Appln No. 09/778,992
Amdt date September 13, 2004
Reply to Office action of July 13, 2004

REMARKS/ARGUMENTS

FIG. 2

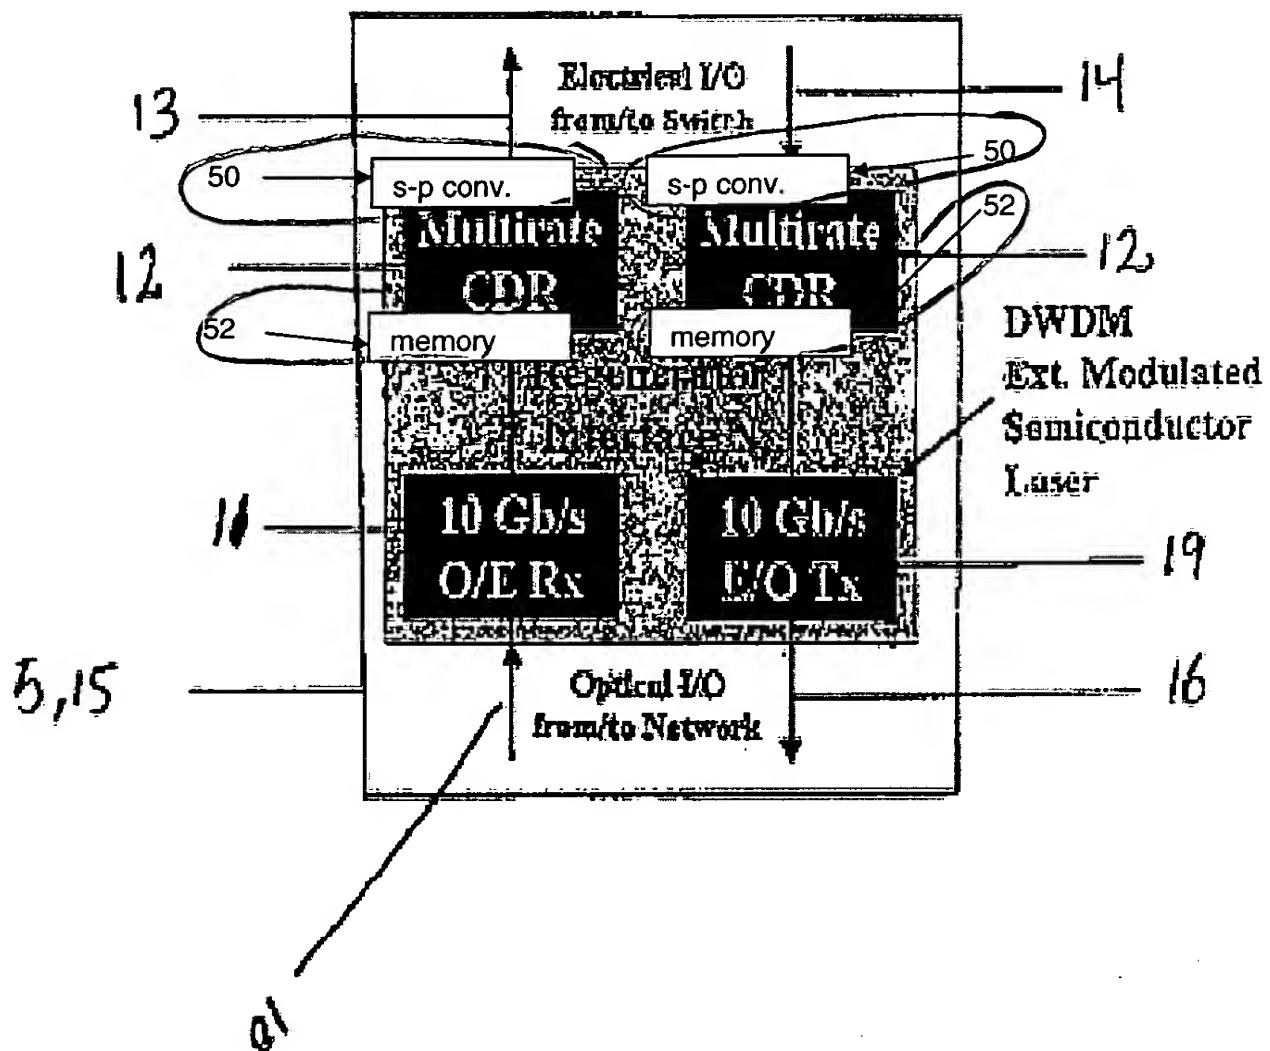
The drawings are objected to because the serial-parallel converter and the memory element must be shown. Again, FIG. 2 is amended to depict the serial-parallel converter (50) and the memory element (52) which are described on page 5 of the specification. Page 5 of the specification has also been amended to incorporate reference numerals from the amended drawing. No new matter is added. Accordingly, Applicant
